UNITED STATES PATENT AND TRADEMARK OFFICE

Office Action Summary

10/524,863

SATO, TADAYOSHI

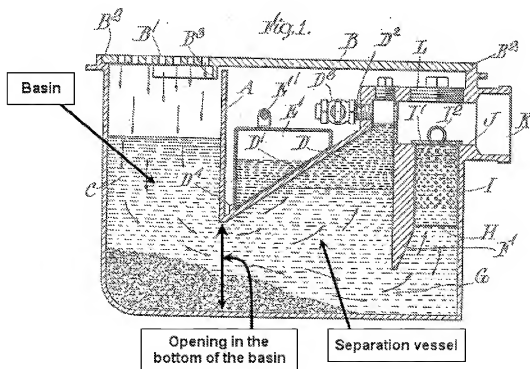
Regarding claim 5, Kelly teaches a sink comprising: a basin (C) having a bottom with an opening, a separation vessel communicating with the opening, a water storage vessel (H) forming a u-shaped passage as a whole together with the separation vessel, a draining means (K), and an open/close means (D3) provided at the side of the separation vessel (fig. 1). How the apparatus functions is a process limitation that does not add structural limitations to the claim.

Regarding claim 7, Kelly further teaches the separation vessel and the water storage vessel are adjacent each other with a common partition member (F) forming the u-shaped passage, and the draining means (K) has a structure with an inlet formed at a

position of the predetermined fluid level on a circumferential side wall of the water storage vessel and a pipe shaped member formed out so as to connect the inlet and outside of the water storage vessel (fig. 1).

Regarding claim 8, Kelly further teaches the separation vessel and the water storage vessel are adjacent each other with a common partition member (F) forming the u-shaped passage, and the draining means (K) has a structure with an inlet formed at a position of the predetermined fluid level within the water storage vessel and a pipe shaped member formed out so as to connect the inlet and outside of the water storage vessel (fig. 1).
